**Addendum to the Historic Report by Treanor HL
(Formerly Carey & Company)**

Hotel Montgomery and San Jose Tribute Hotel Project
211 South First Street
San Jose, California

ADDENDUM TO HISTORIC REPORT OF MAY 25, 2017

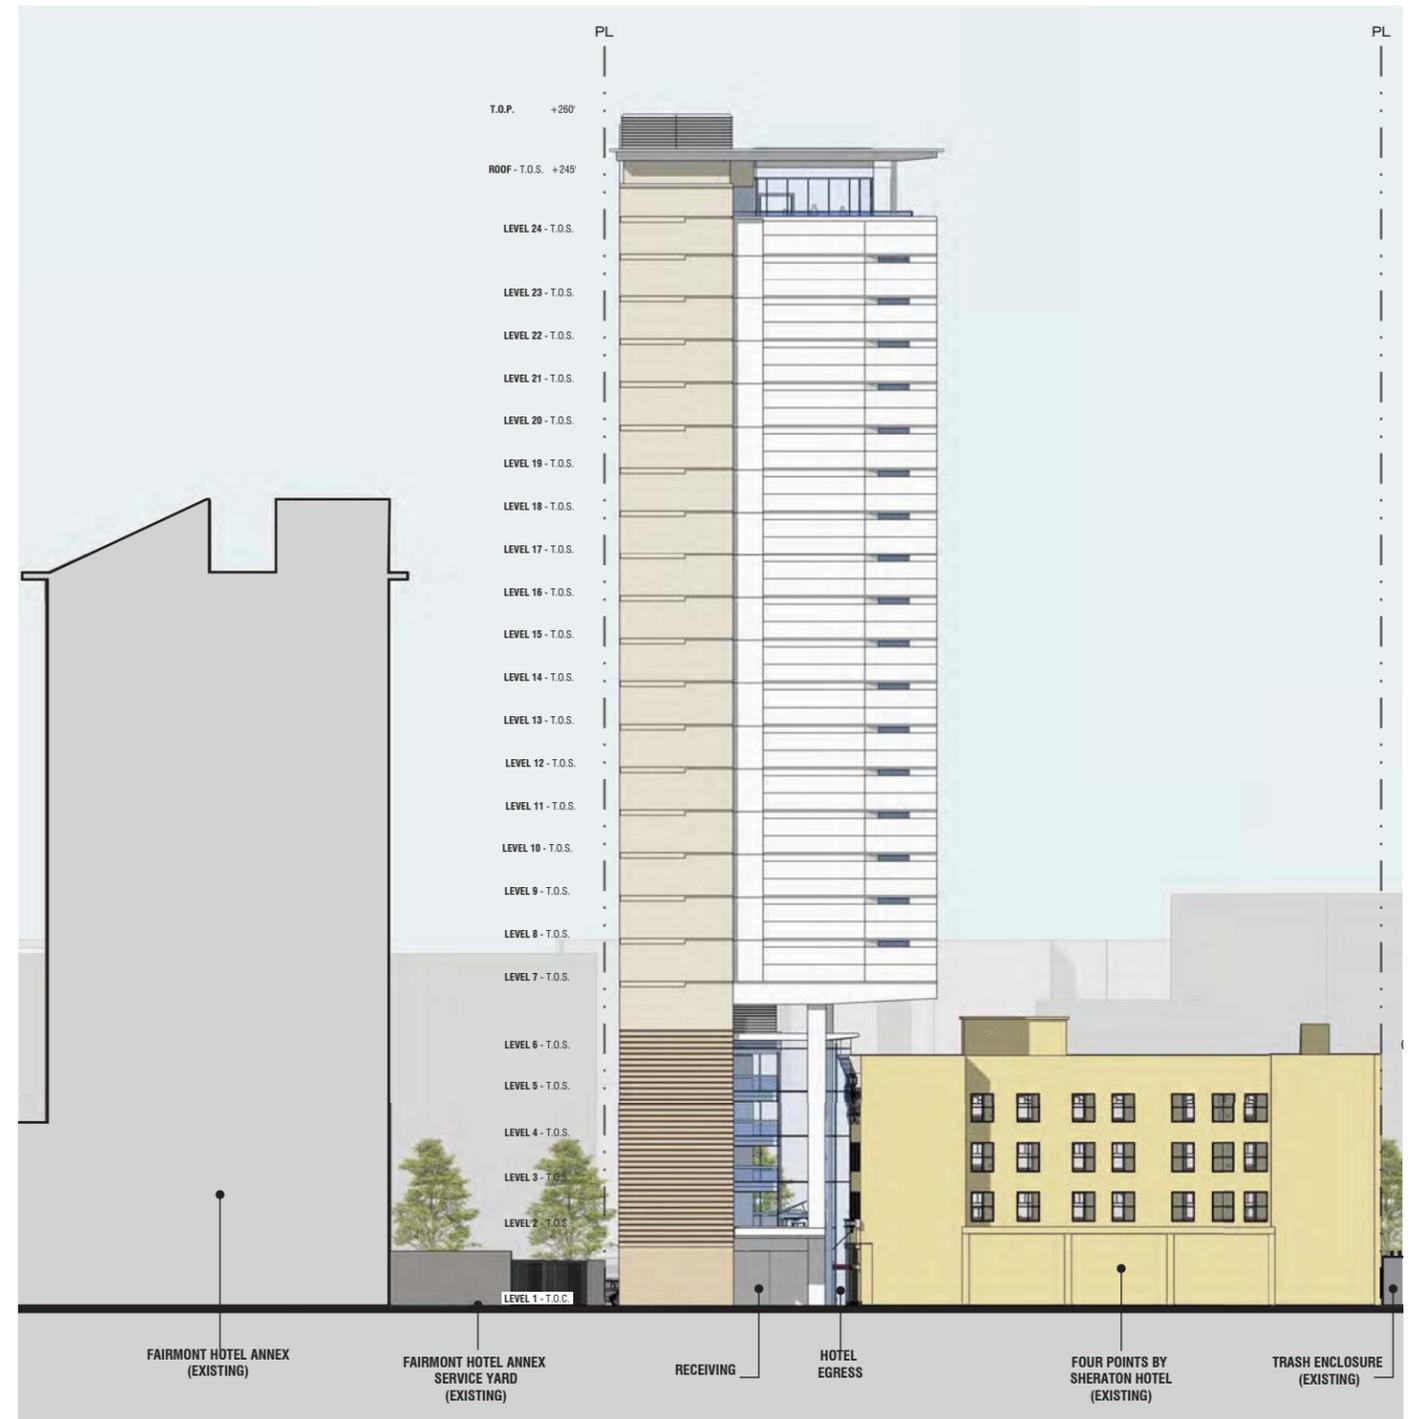
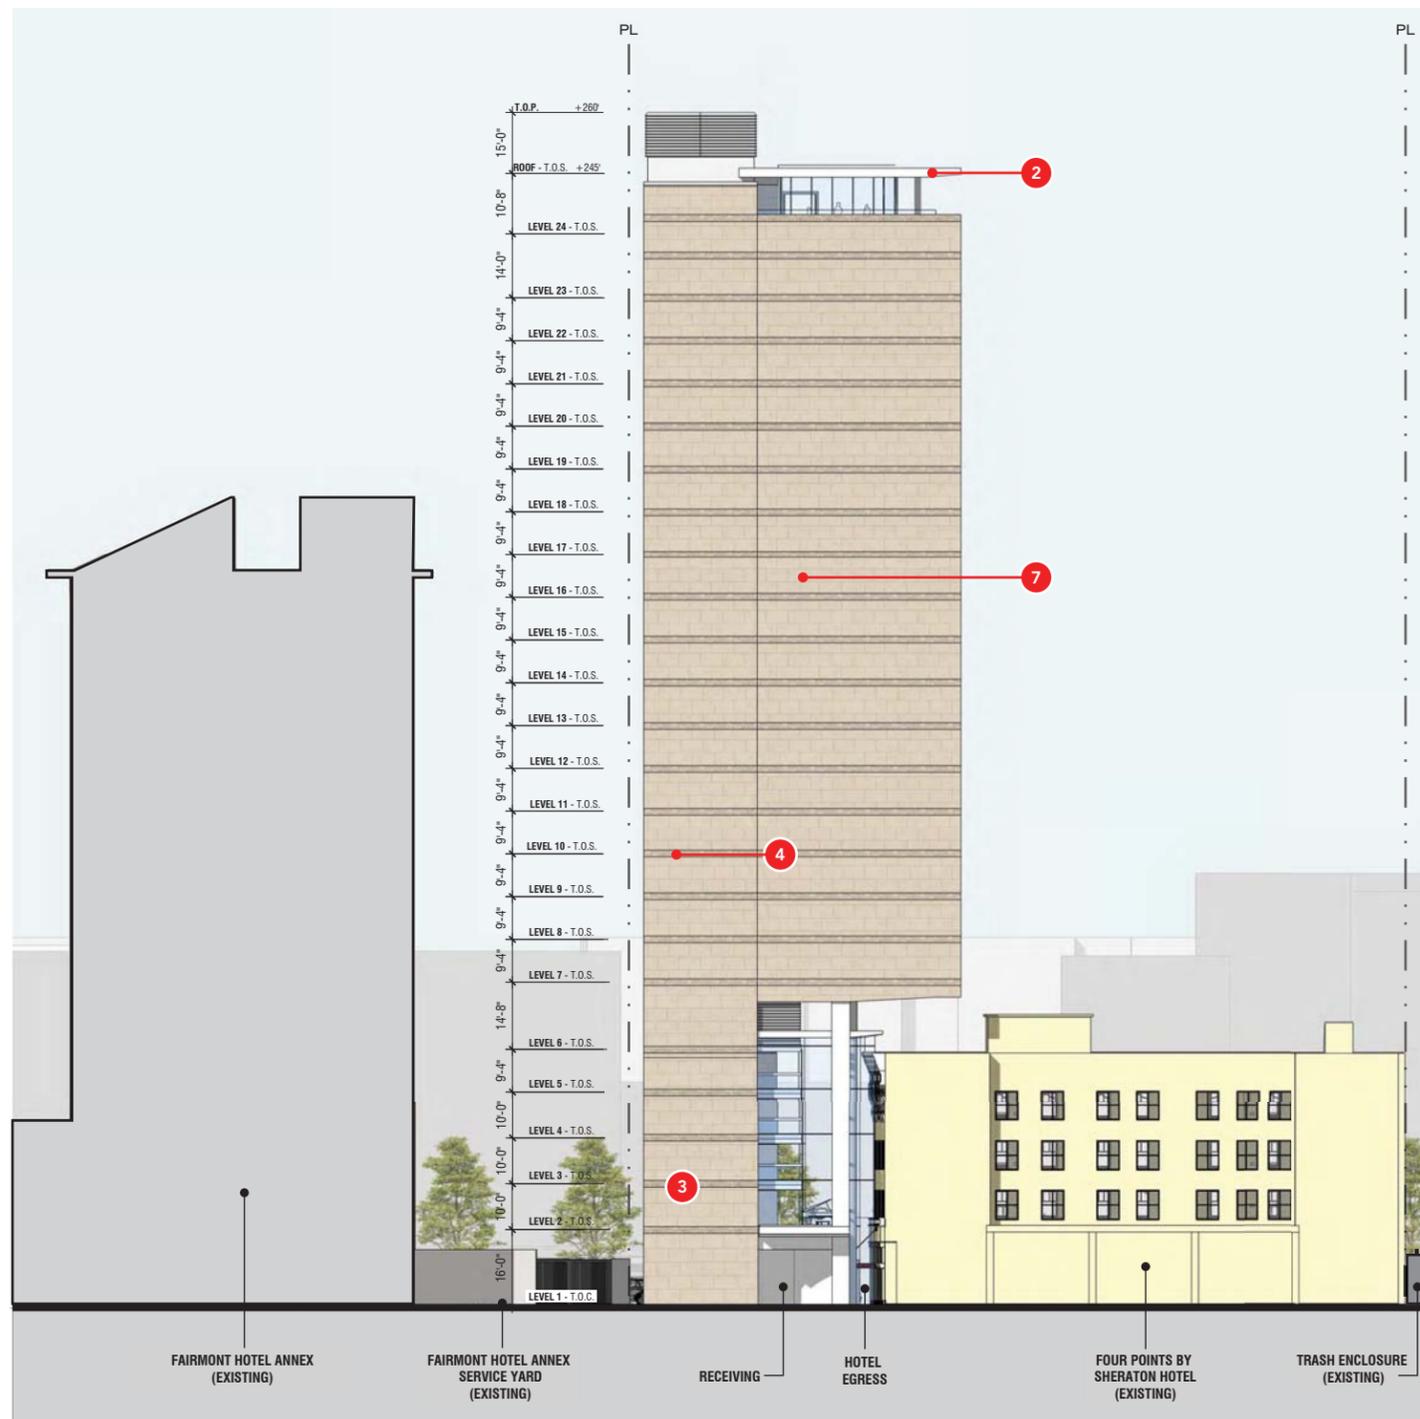
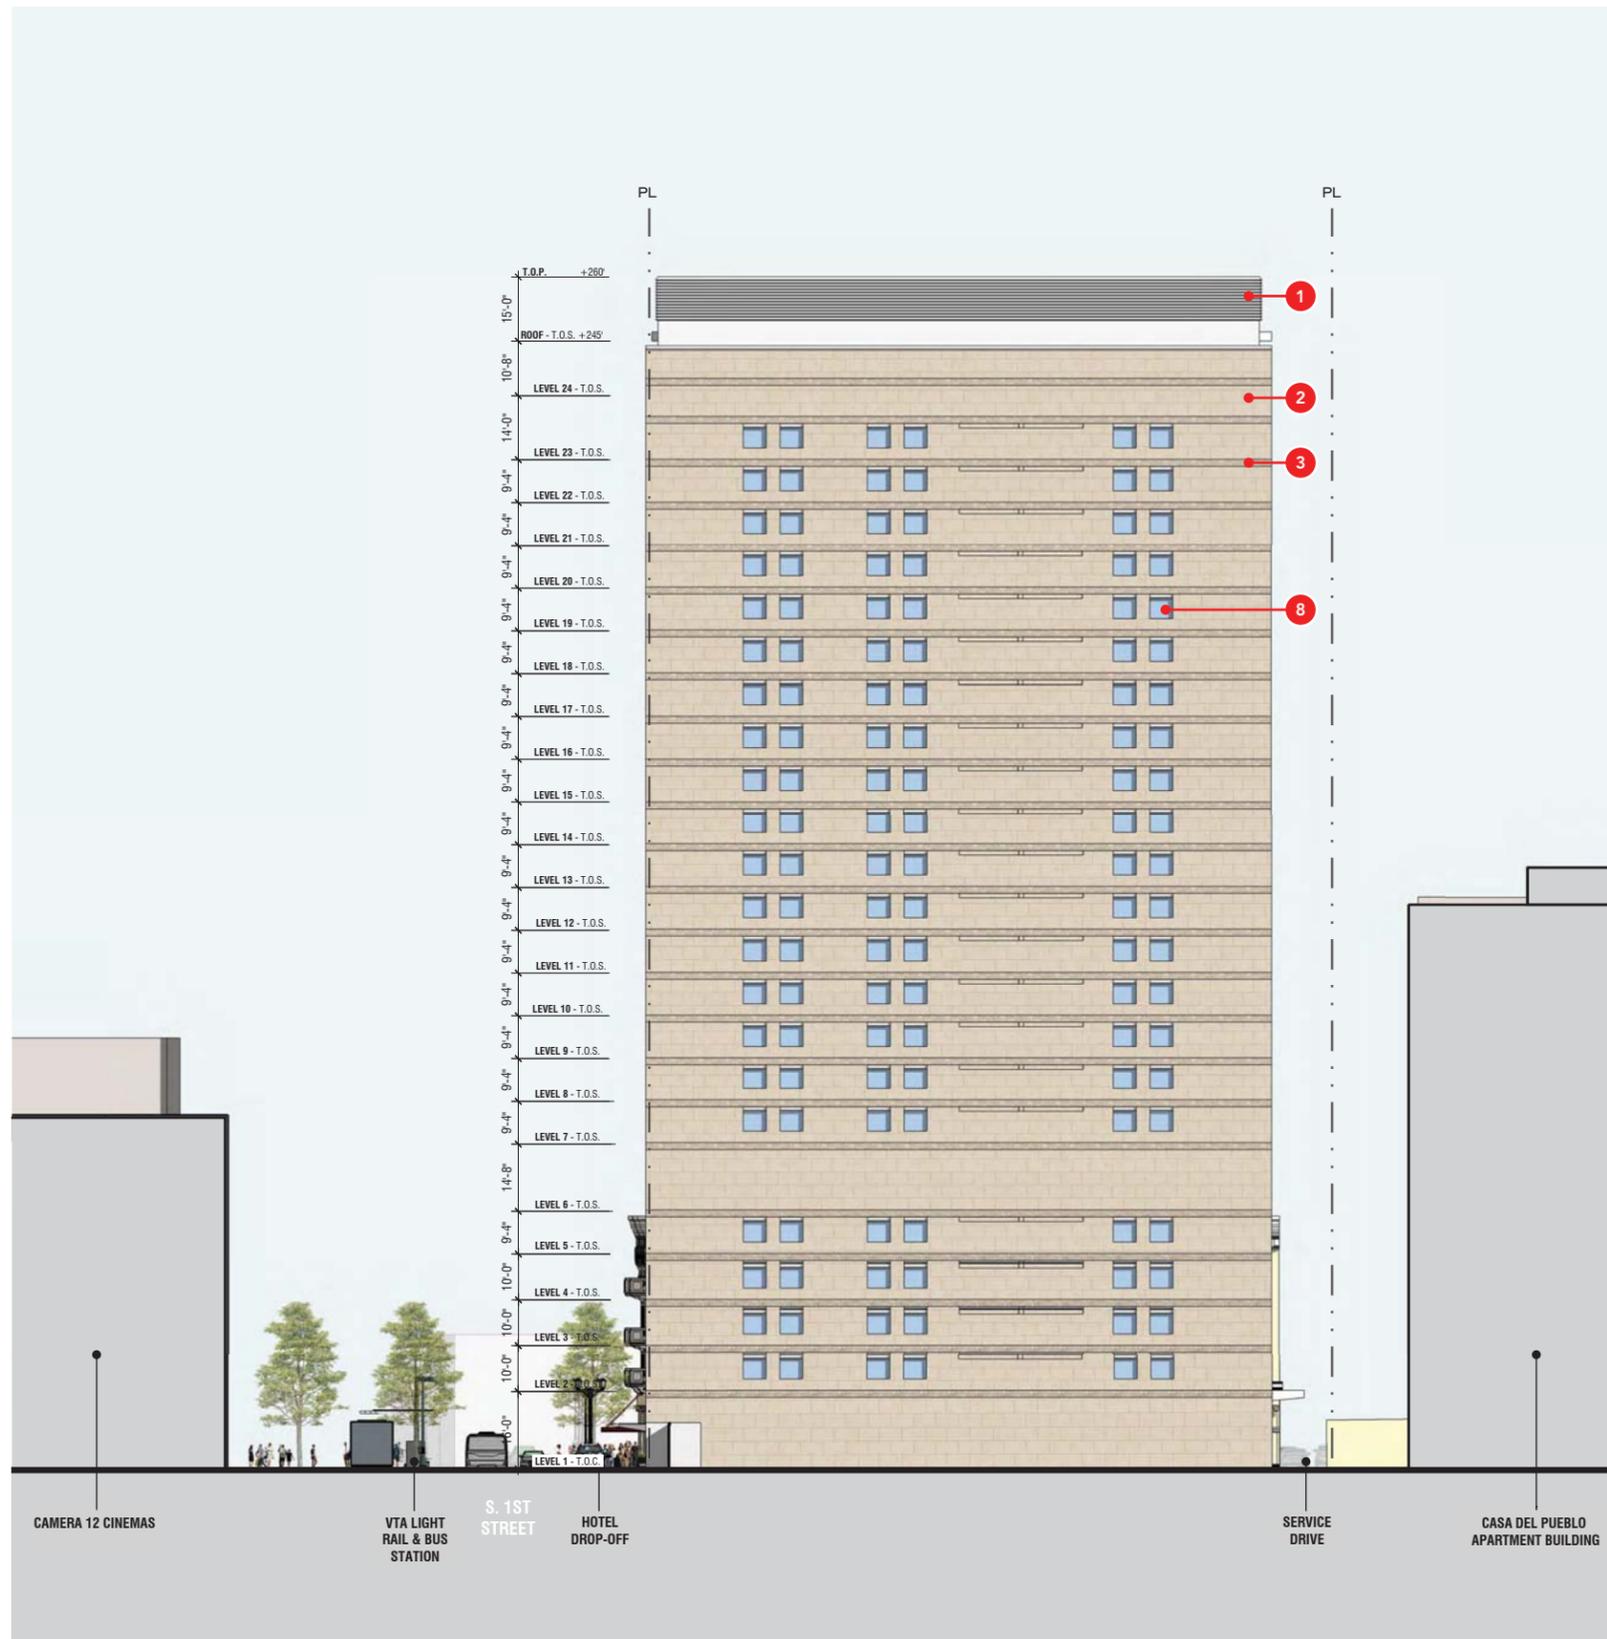
- 1 REFINE CORNER OF TOWER TO BE MORE TRANSPARENT, CANTED SOUTH FACE TO OFFER GESTURE DEFERENTIAL TO THE EXISTING HOTEL
- 2 ROOFTOP CANOPY TO BE ENHANCED AND RAISED FOUR FEET WITH OUTBOARD EDGE WRAPPED AROUND THE PERIMETER OF THE PENTHOUSE TO GIVE MORE PROMINENCE
- 3 EAST, NORTH AND WEST WALLS TO BE REFINED WITH COLOR

- 4 NORTHEAST AND NORTHWEST CORNERS OF THE TOWER TO BE REFINED WITH RECESSED BANDS - A MODERN VERSION OF QUOINS - TO MODULATE THE SCALE AND PROVIDE VISUAL INTEREST
- 5 RECESS BALCONIES TO SPANDREL DEPTH AT ATRUM ENCLOSURE AND TEXTURE SYMPATHETIC TO EXISTING HOTEL, AND TO DIFFERENTIATE THE BASE AND SHAFT OF THE TOWER

- 6 RECONFIGURE EXPRESSED TOWER ELEMENTS INTO UNIFORM GRID TO HEIGHTEN CONTRAST WITH CORNER BAY
- 7 DEVELOP ARTICULATION AND REFINE BUILDING SCALE

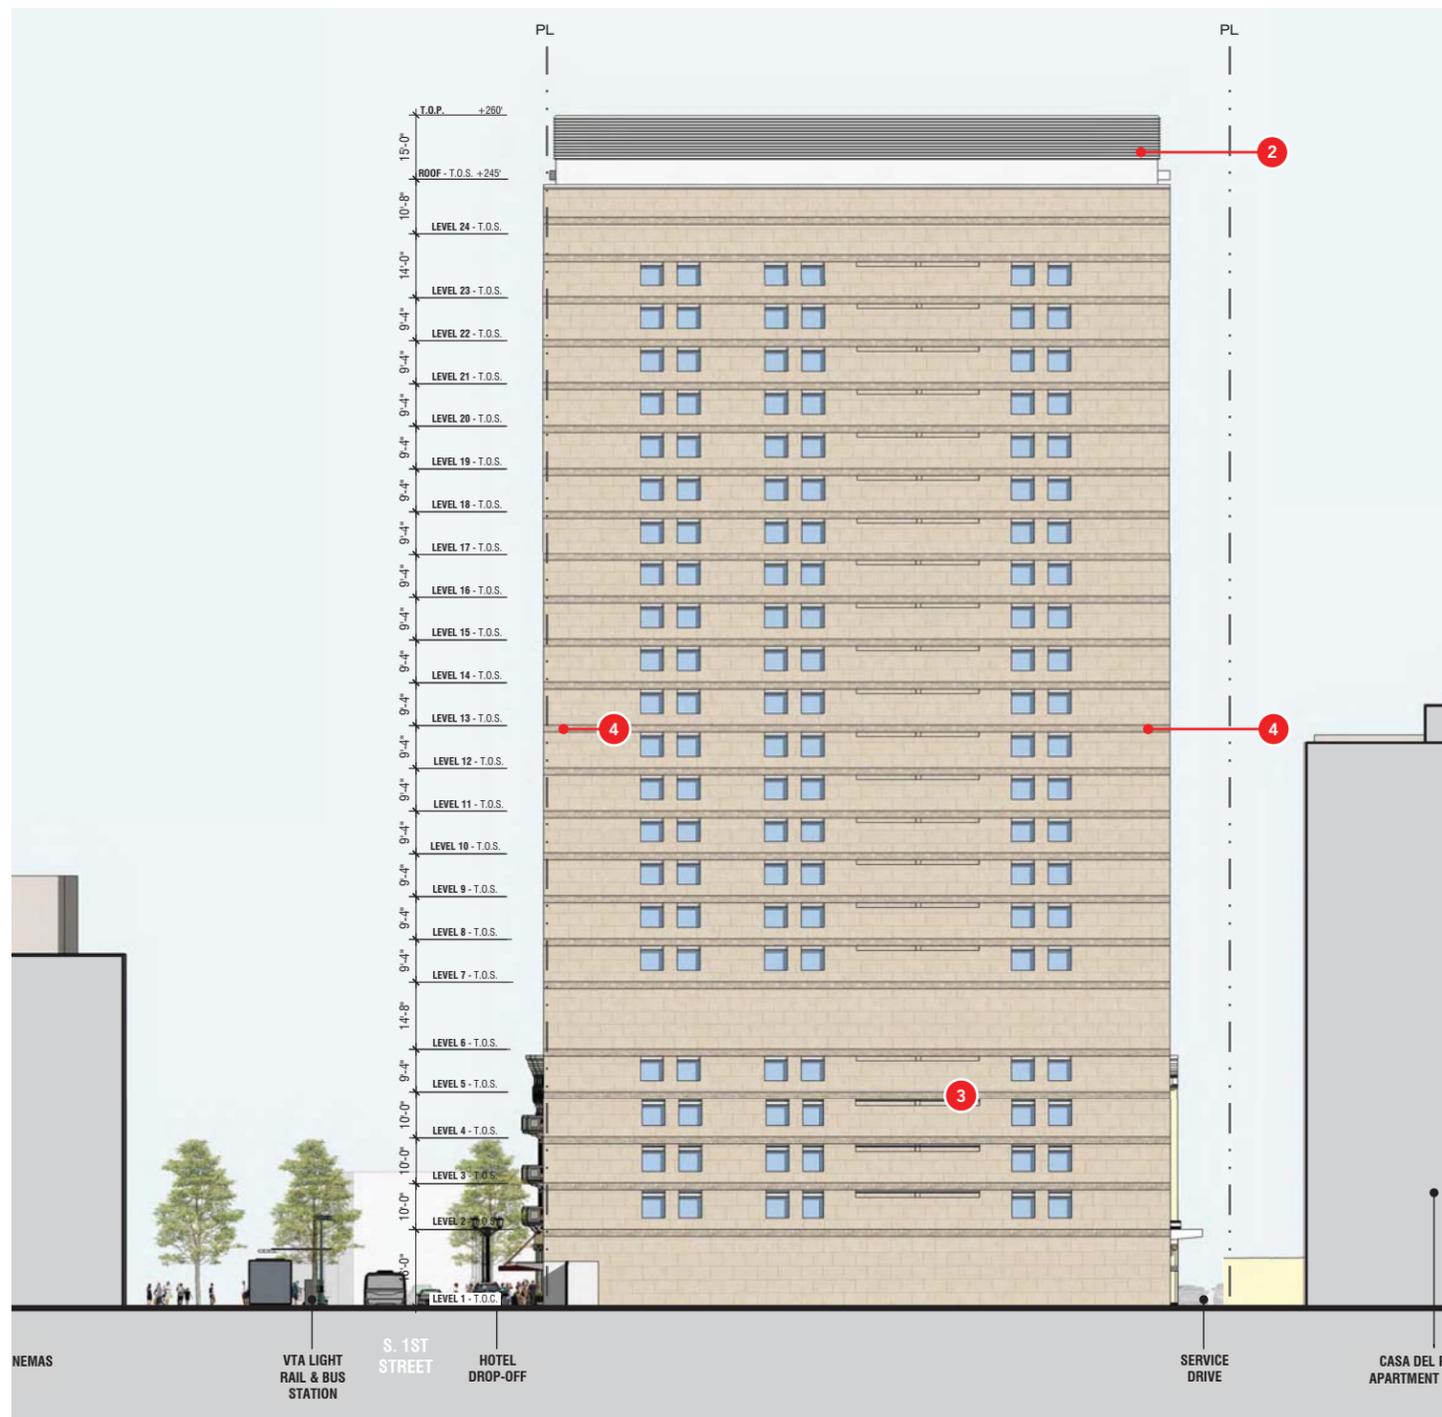
- 1 REFINE CORNER OF TOWER TO BE MORE TRANSPARENT, CANTED SOUTH FACE TO OFFER GESTURE DEFERENTIAL TO THE EXISTING HOTEL
- 2 ROOFTOP CANOPY TO BE ENHANCED AND RAISED FOUR FEET WITH OUTBOARD EDGE WRAPPED AROUND THE PERIMETER OF THE PENTHOUSE TO GIVE MORE PROMINENCE
- 3 EAST, NORTH AND WEST WALLS TO BE REFINED WITH COLOR

- 4 AND TEXTURE SYMPATHETIC TO EXISTING HOTEL, AND TO DIFFERENTIATE THE BASE AND SHAFT OF THE TOWER
- 4 NORTHEAST AND NORTHWEST CORNERS OF THE TOWER TO BE REFINED WITH RECESSED BANDS - A MODERN VERSION OF QUOINS - TO MODULATE THE SCALE AND PROVIDE VISUAL INTEREST
- 5 RECESS BALCONIES TO SPANDREL DEPTH AT ATRUM ENCLOSURE

- 6 RECONFIGURE EXPRESSED TOWER ELEMENTS INTO UNIFORM GRID TO HEIGHTEN CONTRAST WITH CORNER BAY
- 7 DEVELOP ARTICULATION AND REFINE BUILDING SCALE
